City of Carmel-by-the-Sea

ADA Evaluation and Transition Plan

of Various City-Owned Properties

September 28, 2018

K. Main Level North Restroom

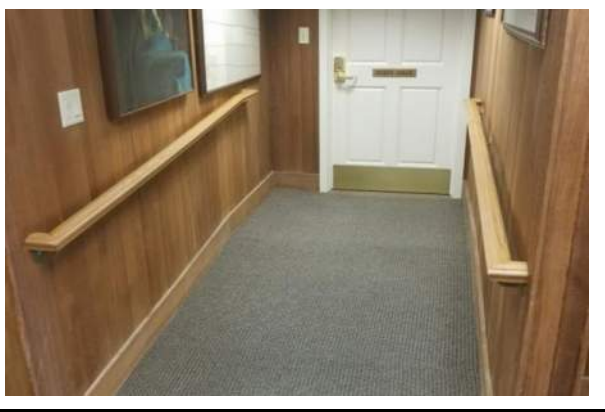
Code Ref.	Priority	Strategy	Budget
1. Signage	11B-703.7.2.6.3	3	A	\$3,450
2. Door: Modify or replace the door to provide a smooth surface on the push side extending the full width of the door.	11B-404.2.10	3	B	
3. Adjust door closer	N/A	3	A	
4. Correcting the maneuvering clearance on the push side of the door	N/A	4	D	
5. Toilet: Providing 60" minimum by 56" minimum clearance around the toilet	N/A	4	D	
6. Grab Bars: Relocate the rear grab bar	11B-604.5.2	3	B	
7. Lavatory: Relocate	N/A	4	D	
8. Remove cabinet on south wall	N/A	1	A	
9. Accessories: Relocate soap dispenser, seat cover dispenser, paper towel dispenser, coat hook	11B-603.5 11B-308	3	A	
10. Light switch: Relocate	11B-308	3	B

X. Admin. Department Reception Counter

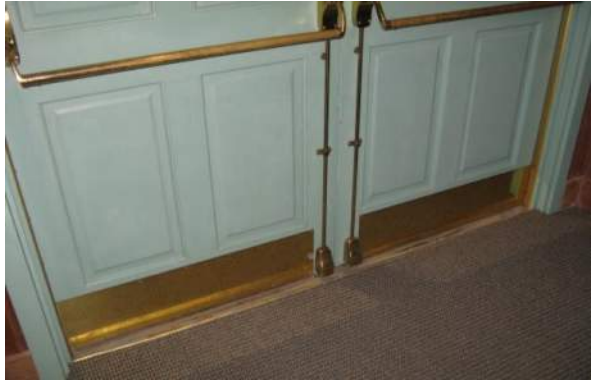
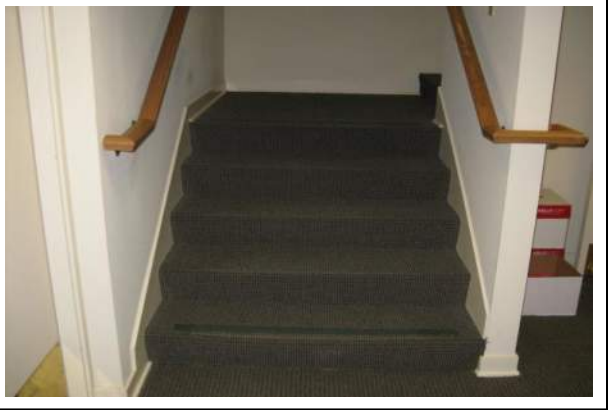
Code Ref.	Priority	Strategy	Budget
1. Modify the counter	11B-904.4	3	B	\$5,200

C. Accessible Parking Space:

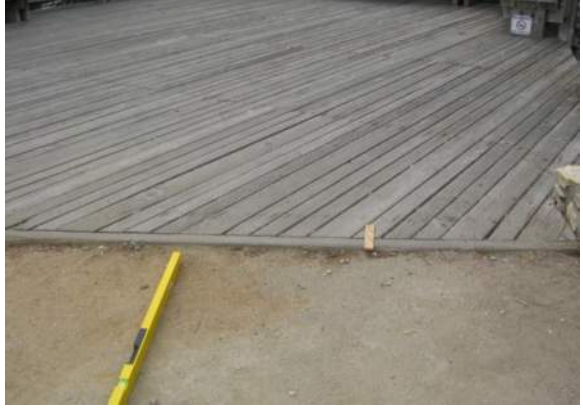
Code Ref.	Priority	Strategy	Budget
1. Regrade parking space and aisle for max surface slope of 1:48 in any direction	11B-502.4	2	D	\$25,300
2. Provide parallel curb ramp	11B-406.3	2	D	
3. Van accessible markings and international symbol of accessibility	11B-502.1 11B502.3 11B-502.6	2	D	
4. Identification signage, Van Accessible, Minimum Fine & Tow Away signs	11B-502.6 11B502.8	2	D

A. *Path of Travel from Public Sidewalk to Primary Entrance.*

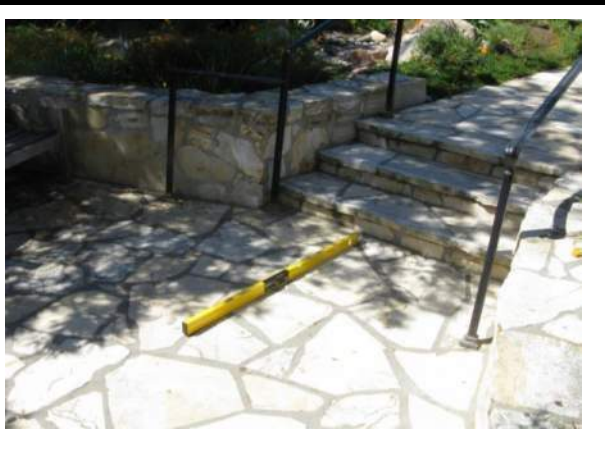
Code Ref.	Priority	Strategy	Budget
1. Providing an accessible route from the public sidewalk to the primary entrance	N/A	4	D	N/A

P. Stair to Mezzanine Level from Lobby

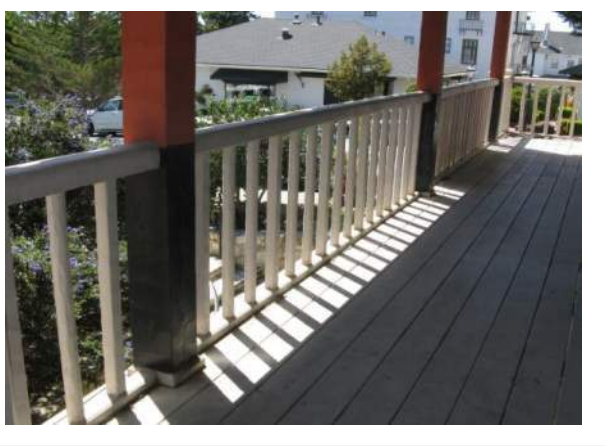
Code Ref.	Priority	Strategy	Budget
1. Replace or modify handrails, both sides of stair	11B-505	3	B	\$16,100
2. Contrasting nosing stripes shall extend full width of stairs at top and bottom tread	11B-504.4.1	3	B

J. Drinking fountain

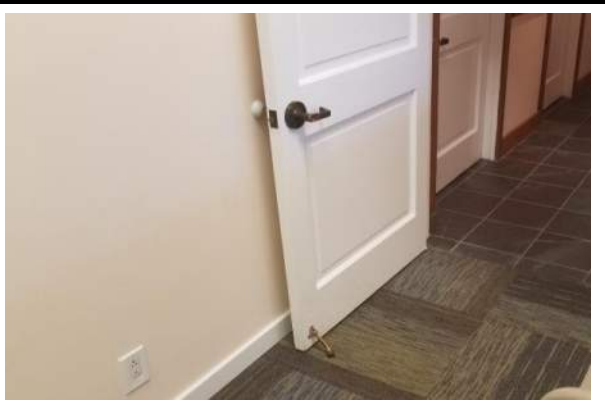
Code Ref.	Priority	Strategy	Budget
1. Modify the existing alcove and provide a dual fountain	11B-602	3	B	\$10,000
2. Provide a countertop drinking fountain in the Children's Restroom	11B-602.2, Exception	3	B

P. Interior Doors in Employee Areas

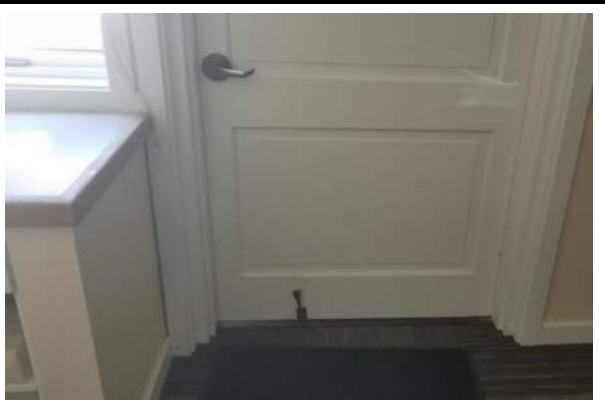
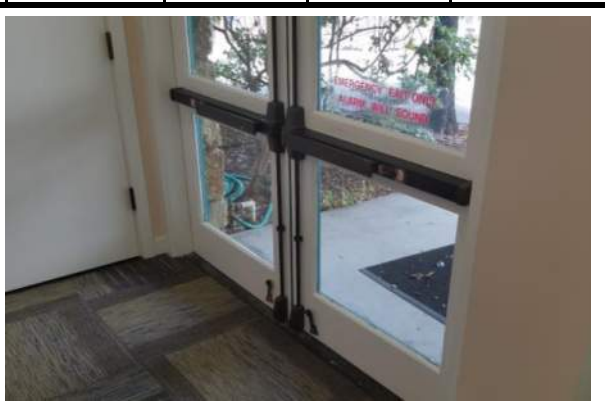
Code Ref.	Priority	Strategy	Budget
1. At three doors: Install offset hinges to provide a clear width of 32 inches	11B-404.2.3	3	B	\$5,500
2. Modify or replace four doors so the surface within 10 inches of the ground has a smooth surface on the push side extending the full width of the door	11B-404.2.10	3	B

B. North Parking Lot: Accessible Parking Spaces

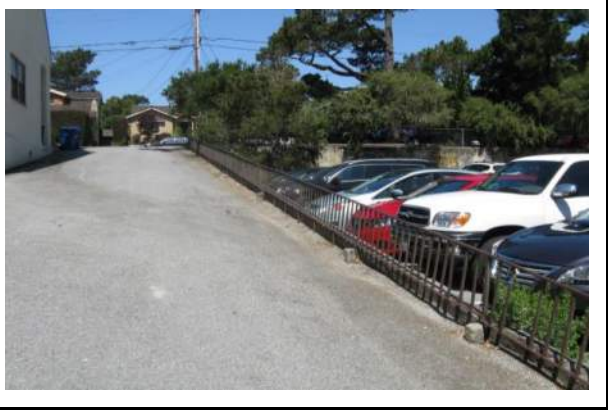
Code Ref.	Priority	Strategy	Budget
1. Add additional accessible parking spaces	N/A	4	D	N/A
2. Regrade parking space and aisle for max surface slope of 1:48 in any direction	11B-502.4	3	D	\$32,300
3. Van accessible markings and international symbol of accessibility	11B-502.	3	D	
4. Identification signage, Van Accessible, Minimum Fine & Tow Away signs	11B-502.6 11B502.8	3	D	
5. Provide a 48" wide min. crosswalk fro the access aisle to the ramp to Carpenter Hall with running slope at 1:20 max and cross slope at 1:48 max.	11B-403 and 11B-247.1.2.5	3	D

F1. Original North Portion Drinking Fountain

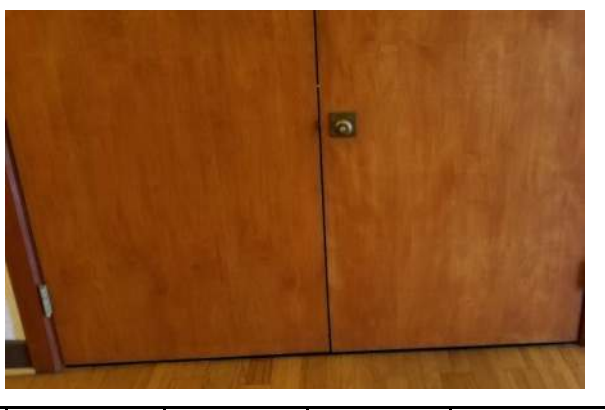
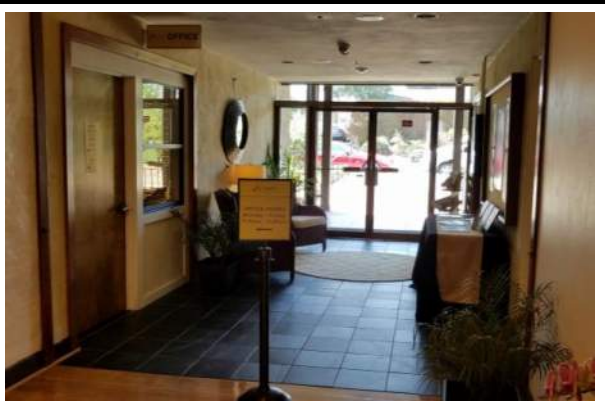
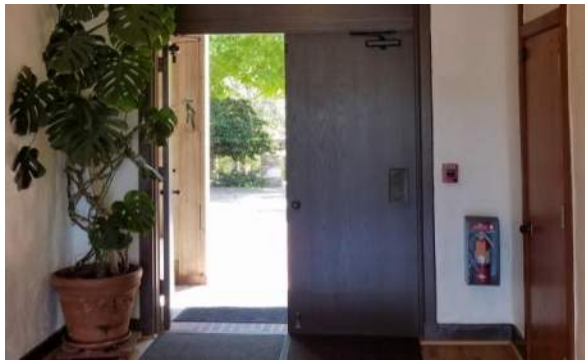
Code Ref.	Priority	Strategy	Budget
1. Replace drinking fountain	11B-602	3	B	\$5,790

T1. Orchestra Level Drinking Fountain

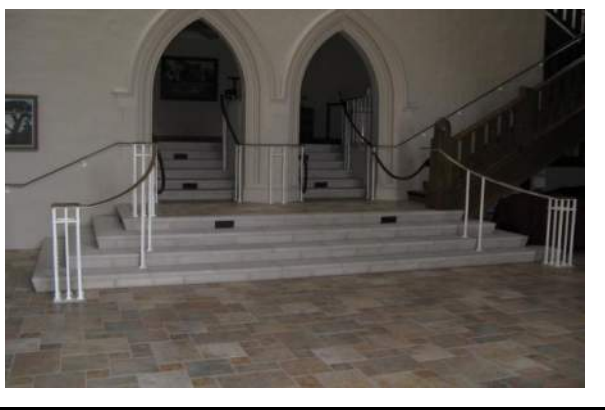
Code Ref.	Priority	Strategy	Budget
1. Replace drinking fountain	11B-602	3	B	\$7,200

U1. Studio Level Unisex Toilet Rooms (2)

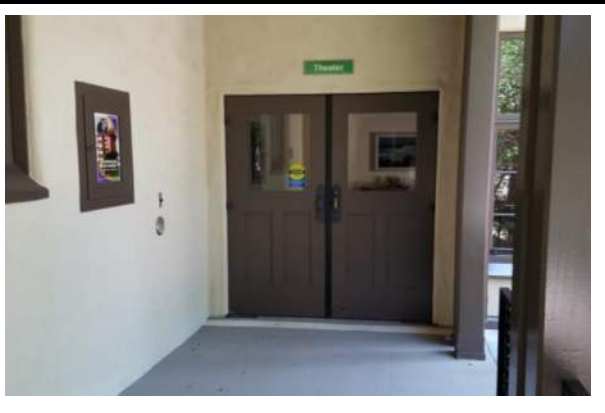
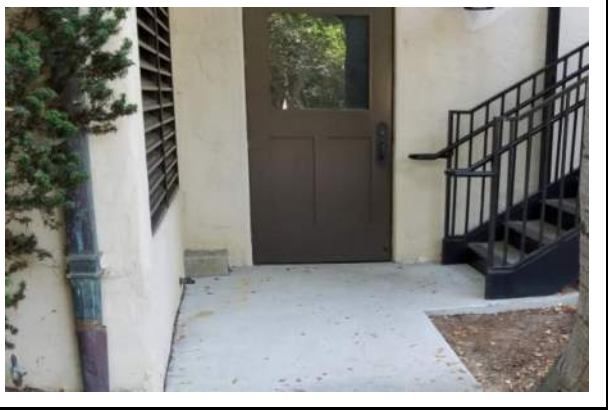
Code Ref.	Priority	Strategy	Budget
1. Replace door & wall signage	11B-703.7.2.6.3	3	A	\$4,500
2. Adjust door closer	N/A	3	A	
3. Correct the maneuvering clearance on the push side of the door	N/A	4	D	
4. Relocate toilet paper dispenser	11B-604.7	2	B	
5. Grab Bars: Relocate the rear grab bar	11B-604.5.2	3	B	
6. Shower Compartments: Providing 30" wide by 60" deep minimum shower compartment with a full open width on the long side	N/A	4	D

<p>A. <i>Path of Travel from Public Sidewalk to Primary Entrance is not provided.</i></p>	
---	--

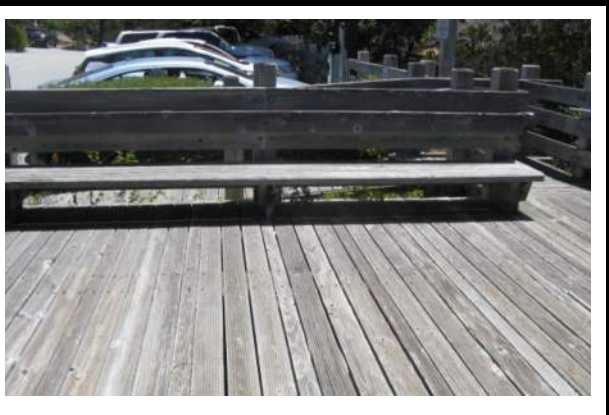
Code Ref.	Priority	Strategy	Budget
1. Provide an accessible route from the public sidewalk to the primary entrance	N/A	4	D	N/A
